Photocatalytic C(sp³)–C(sp³) cross-coupling of carboxylic acids and alkyl halides using a nickel complex and carbon nitride

Corresponding Author: Professor Gianvito Vilé

This file contains all reviewer reports in order by version, followed by all author rebuttals in order by version.

Figure 1. Base effect on the decarboxylation process.

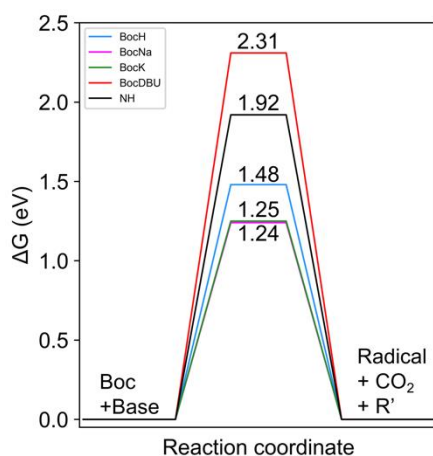
(1) In an earlier publication, the authors reported carbon-oxygen coupling from the same coupling partners employing single atom Ni anchored on carbon nitride. Carbon-oxygen coupling also proceed with different yield, depending on conditions. It is worth to find the underlying reasons for different coupling manners, which will increase the scientific impact and guide catalyst development.

The formation of compounds **3a** and **4a** proceeds via distinct reaction pathways. Therefore, when the pathway leading to **3a** is slowed or inhibited, the formation of **4a** becomes more favorable. We propose that the selectivity for **3a** is linked to a preferred single electron transfer (SET) step, which ultimately leads to the decarboxylation process. Among the factors promoting SET, we emphasize the use of 420 nm light over 460 nm, which corresponds to the maximal absorbance of carbon nitride. This may help stabilize its triplet state. Furthermore, in acetonitrile, a polar solvent known for facilitating SET, the electron transfer from photoexcited nCN_x to the deprotonated carboxylic acid becomes the dominant pathway. Finally, a selectivity trend was observed between the formation of **3a** and the type of base utilized. To stress this point, Stern-Vomer experiments indicate a stronger interaction of the photoexcited nCN_x between **1** in presence of Na₂CO₃ than in presence of Cs₂CO₃. Besides, **we modeled the interactions between Na, K, and DBU with the deprotonated carboxylic acid by considering the Boc-protected L-proline**. The results suggest that Na may better promote the decarboxylation process while the DBU will block it (see Figure 1). Collectively, these results shed light on the factors that govern the interplay between carbon-oxygen and carbon-carbon coupling, and expand the versatility of single-atom catalysts for diverse coupling reactions. **We have included this discussion in the text.**

Figure 2. Energetic profile for the C-C coupling by considering the (a) proline molecule and the (b) Boc-protected proline.

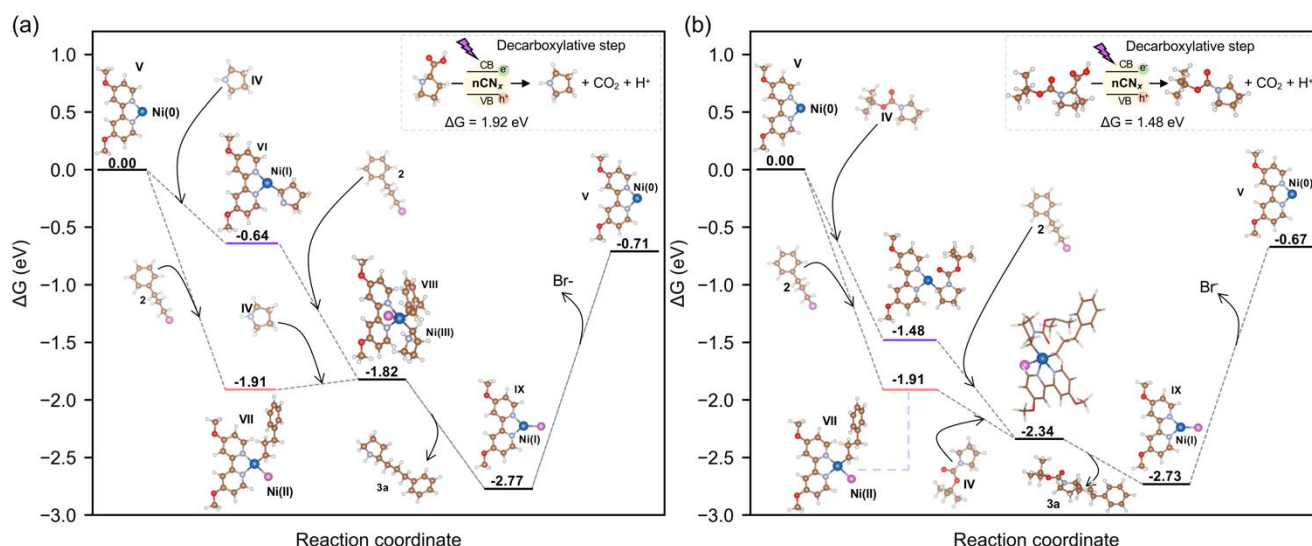
This paper presents DFT calculation data to explain the Ni-catalyzed reaction pathway. However, the DFT data presented, which uses proline, does not offer a sufficiently reliable explanation for the mechanistic pathway. Based on the substrate scope study in this paper, the reactivity and selectivity are influenced by the substituents, with even methyl-substituted proline showing no reactivity. Therefore, it would be more appropriate to present DFT calculation results using Boc-protected proline rather than proline. Additionally, the Ni-catalytic cycle has already been extensively addressed in previous studies (*Nature* 2016, 536, 322–325; *J. Org. Chem.* 2024, 89, 11136–11147; *Science* 2014, 345, 437–440). It would be beneficial to develop data that provides deeper mechanistic insights into decarboxylation beyond esterification.

We appreciate the Reviewer's comment on the DFT part. The suggested papers (*Nature* **2016**, 536, 322–325; *J. Org. Chem.* **2024**, 89, 11136–11147; *Science* **2014**, 345, 437–440) have been included in the manuscript.

We also agree with the Reviewer's point on the Boc-protected proline; we have thus addressed the point by calculating the full reaction profile in the presence of the Boc group. As shown in the amended paper, the reaction energy is equivalent with and without Boc, although more stable intermediates are formed when comparing Boc-protected and free proline. This result is not surprising. In fact, while the Boc group serves as a protective group in proline to prevent its amine functionality from unwanted reactions, influencing the local environment of the reactant and intermediate states, the fact that DFT calculations did not show any significant change in the reaction profile is due to the inherent nature of DFT as a local optimization method. DFT tends to capture the electronic structure accurately but may not fully account for long-range effects or subtle changes that could arise from the conformational flexibility or dynamic interactions of the Boc group in a real reaction context. Therefore, the overall reaction mechanism remains energetically equivalent in both cases, which is consistent with the predictions from DFT. As a result, all our mechanistic conclusions are

unchanged, and, for example, the Ni(II) intermediate remains still more stable than Ni(I), as shown below in Figure 2 where the energetic profile with proline (a) and the Boc-protected proline (b) are shown.

Figure 1. Effect of the decarboxylation process in the presence of sodium (a) and potassium (b) cations from inorganic bases.

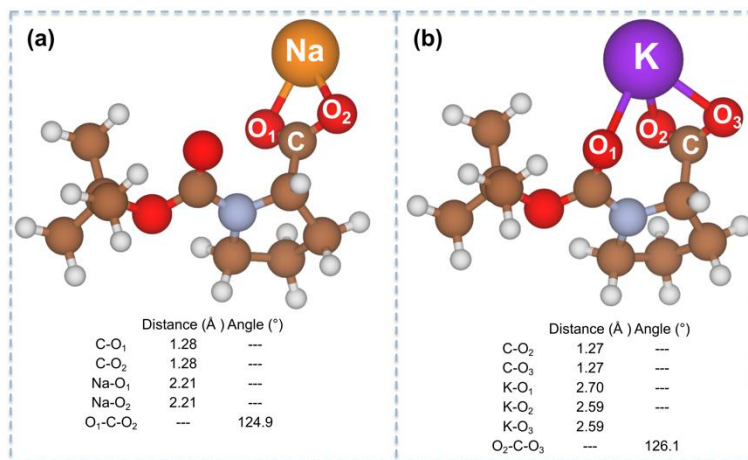
Comment #4: The authors propose that energy differences resulting from interactions between 1 and the base explain variations in product yields. This rationale is plausible in cases without a base (1.48 eV) or with DBU (2.31 eV). However, the manuscript fails to address the significant discrepancies between Na₂CO₃ and K₂CO₃ results. Despite their similar intermediate energies (1.24 eV for Na₂CO₃ and 1.25 eV for K₂CO₃),

their yields differ substantially, with Na₂CO₃ yielding 33% of **3a** and 17% of **4a**, while K₂CO₃ yields 34% and 44%, respectively. Additional justification or experimental data is needed to clarify these differences.

We thank the Referee for his comment. The interaction of sodium and potassium cations from sodium and potassium carbonates with deprotonated Boc-L-proline leads to the release of radical Boc-proline and CO₂, with similar energy barriers for each cation: 1.24 eV for Na₂CO₃ and 1.25 eV for K₂CO₃. However, the sodium cation forms an intermediate that has a stronger and more localized basic environment compared to that of the potassium-based intermediate. This effect is primarily attributed to the smaller size of the sodium cation and its electronic interactions with the deprotonated Boc-L-proline. The sodium cation enhances the stabilization of the intermediate by forming two bonds with oxygen atoms, each measuring approximately 2.21 Å in length (**Figure 1a**). This strong interaction favors the selective formation of product **3a** over byproduct **4a**. In contrast, the potassium cation forms an intermediate with three bonds to oxygen atoms: two at 2.59 Å and one at 2.70 Å (**Figure 1b**). These weaker interactions do not provide the same stabilizing effect, resulting in the formation of both product **3a** and byproduct **4a** at comparable rates. **This discussion has now been included in the revised manuscript.**
